# SPANISH FORK

## PLANNING COMMISSION AGENDA

WEDNESDAY, MARCH 3, 2004

**To:** Planning Commission  
**From:** Emil Pierson, City Planner  
**Date:** March 3, 2004  
**Subject:** Hugh/Hill "River Cove" Rezone – Tabled from February 4, 2004  
**Location:** 900 South and Del Monte Rd.

**RIVER COVE SUBDIVISION**  
SPANISH FORK CITY, UTAH COUNTY, UTAH  
PARTS OF SECTIONS 24 & 25,  
TOWNSHIP 8 SOUTH, RANGE 2 EAST S.L.B. & M.  
FEBRUARY 2004 SHEET 2 OF 3  
PLANNED UNIT DEVELOPMENT RESIDENTIAL SUBDIVISION  
SPANISH FORK CITY, UTAH COUNTY, UTAH

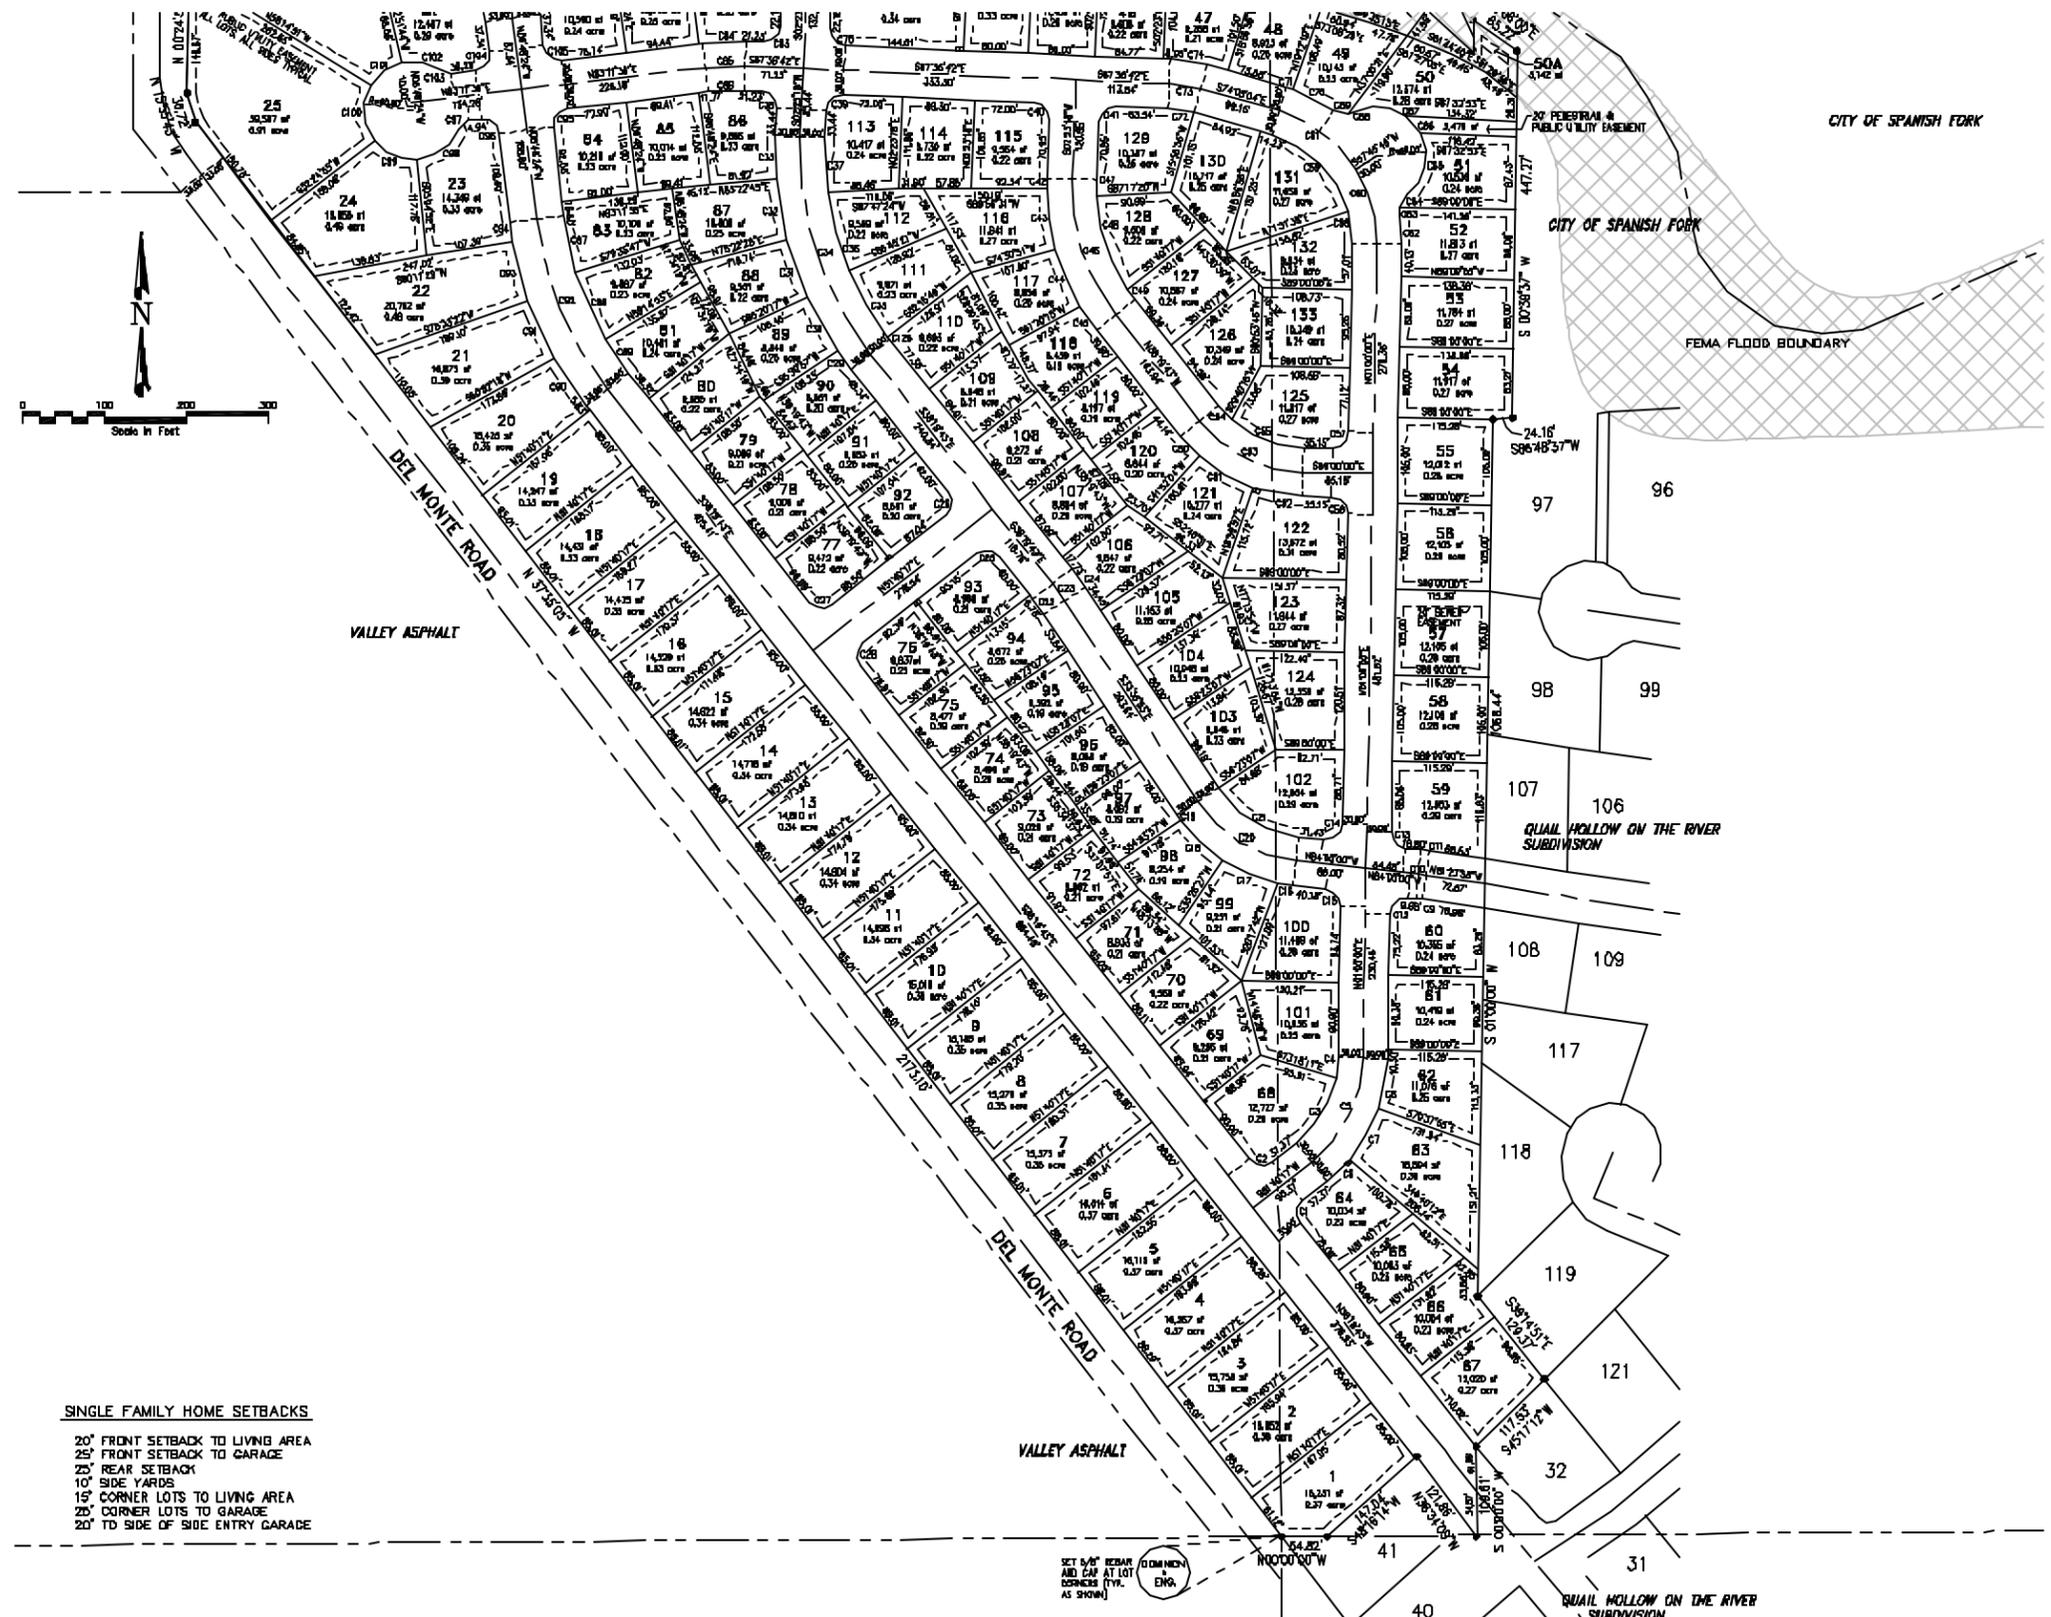
1. Install improvements along Del Monte Rd., with the exception of the sidewalk,
2. No hill area excavation is to take place without approval from the city engineer,

3. Provide a flood plain update and a wetlands report to the city,
4. Upon development of 50 percent of the lots, a 14-foot asphalted pedestrian access between lots 50 and 51 connecting to the city trail is to be bonded for and installed at the developer's expense,

10. Construct the River Cove Project as per the preliminary plan document contained in the packet,
11. The developer is to provide an engineering study of the stability of the existing river rip rap,

17. Have a 20-foot access easement along the south side of the river for maintenance purposes,
18. Point system is approved as shown on the updated attached sheet,

19. All open space areas are to be deeded to the city as part of the 1<sup>st</sup> plat
20. Any grading of the hillside is to be re-vegetated,
21. Feeder power line is to come off the hill at lot 1 and follow along River Ridge Lane,
